Final Product/Process Change Notification

Document #:FPCN23609X1

Title of Change:	Update to FPCN23609X: Removal of products listed in the original FPCN "Second source site addition for final test and shipping tray change for AR0330 CSP products."
Proposed First Ship date:	23 Apr 2021 or earlier if approved by customer
Contact Information:	Contact your local ON Semiconductor Sales Office or Geethakrishnan.Narasimhan@onsemi.com
PCN Samples Contact:	Contact your local ON Semiconductor Sales Office or <PCN.samples@onsemi.com> . Sample requests are to be submitted no later than 30 days from the date of first notification, Initial PCN or Final PCN, for this change. Samples delivery timing will be subject to request date, sample quantity and special customer packing/label requirements.
Additional Reliability Data:	Contact your local ON Semiconductor Sales Office or Amy.Wu@onsemi.com
Type of Notification:	This is a Final Product/Process Change Notification (FPCN) sent to customers. FPCNs are issued 90 days prior to implementation of the change. ON Semiconductor will consider this change accepted, unless an inquiry is made in writing within 30 days of delivery of this notice. To do so, co

Original Case Outline Drawing (2inch Tray)

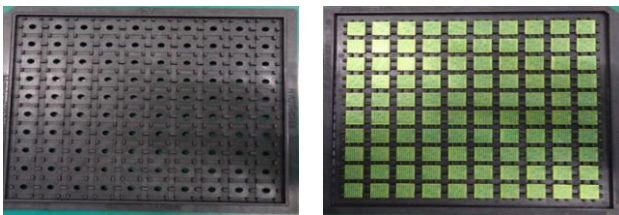
There is no product marking change as a result of this change. The difference in appearance of the tray is shown below.

2inch : 5*5=25ea

Proposed Case Outline Drawing (4inch Tray):

4inch : 10*10=100ea
